Access Compliance Report

Public Rights-of-Way

Intersection ID: 8684	Main Street: CENTRE_ST	Cross Street: DARBY_AV	Location:	N
ADA ID: 03147EC3ACE5	Ramp Type: BlendTrans2	Initial Pass/Fail: Fail	Overall Compliance: No	Severity Score: 10

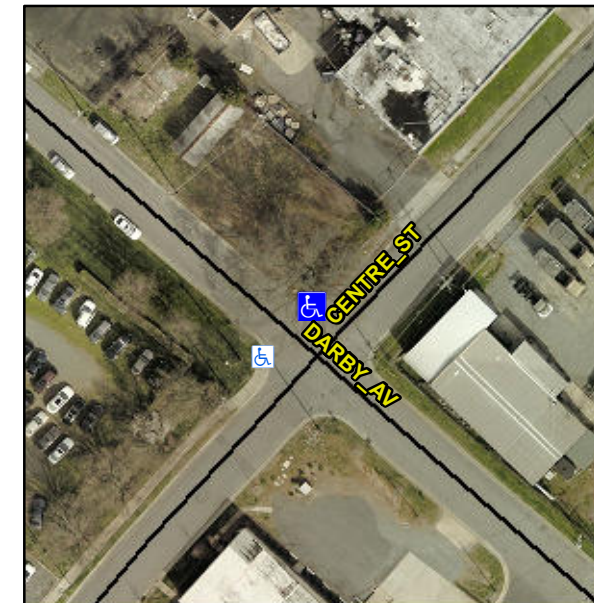
Surveyor Notes:

NO LT SW

PROW/ADA:

R304.5.1, R304.5.3

Compliance	Description	Data	Compliance	Description	Data
N/A	Ramp Length (in)	59.0	Yes	BlendTrans Slope (%)	4.5
No	Ramp Width (in)	47.0	No	BlendTrans XSlope (%)	4.1
N/A	Flare Type LT	N/A	N/A	Flare Type RT	N/A
N/A	Flare Slope LT (%)	N/A	N/A	Flare Slope RT (%)	N/A
N/A	Flare Traversable LT?	N/A	N/A	Flare Traversable RT?	N/A
N/A	Landing Length (in)	N/A	N/A	DWS Provided?	N/A
N/A	Landing Width (in)	N/A	N/A	DWS Contrast?	N/A
N/A	Landing Slope (%)	N/A	N/A	DWS Length (in)	N/A
N/A	Landing X Slope (%)	N/A	N/A	DWS Full Width?	N/A
N/A	Landing Curb? (Y/N)	N/A	N/A	DWS Offset (in)	N/A
N/A	Shared Landing?	N/A			
N/A	Gutter Ponding?	N/A	N/A	Gutter Slope (%)	N/A
N/A	Gutter Lip Ht (in)	N/A	N/A	Gutter X Slope (%)	N/A
N/A	Painted X Walk1?	No	N/A	Painted X Walk2?	N/A
	X Walk 1 Direction	To SW		X Walk 2 Direction	N/A
	X Walk 1 Width (in)	N/A		X Walk 2 Width (in)	N/A
	X Walk 1 Slope (%)	2.7		X Walk 2 Slope (%)	N/A
	X Walk 1 X Slope (%)	2.0		X Walk 2 X Slope (%)	N/A

Possible Solutions:

Remove & Replace Curb Ramp With Two New Directional Ramps or Equivalent.
